Proposed Revisions to a Standard Plans Index

Index Number: 700-101

Typical Sections for Placement of Single and Multi-Column Signs

Add retroreflective strip to static WWD sign column, Case X

CASE X

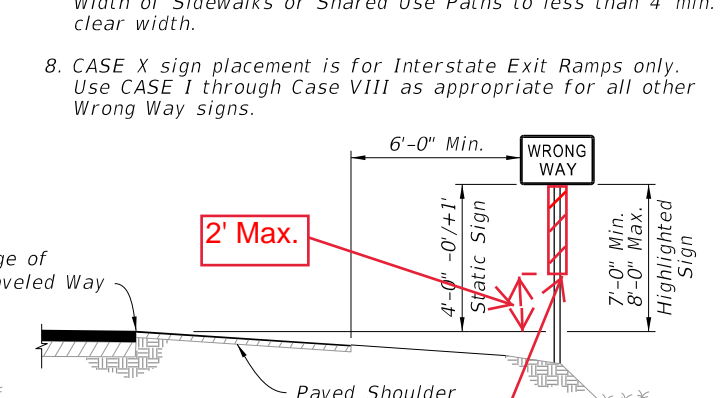
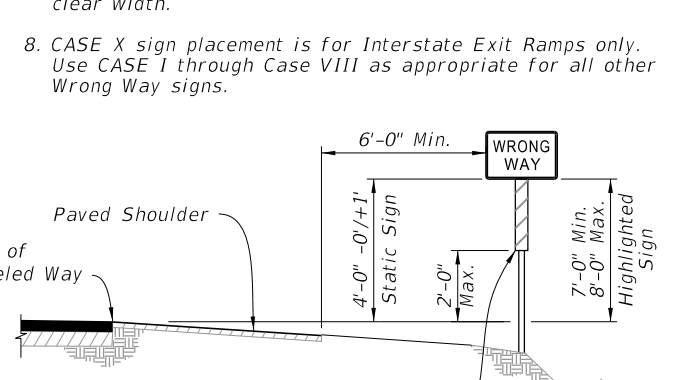
FDM 230.4 states to place retroreflective strip on static WWD sign column. The MUTCD Section 2A-21 "it shall be placed for the full length of the support from the sign to within 2 feet above the edge of the roadway..." An update to Standard Specification 700 is required to clarify the use of the retroreflective strip.

Install Retroreflective Strip in Accordance with Specification 700 (Static Signs Only)
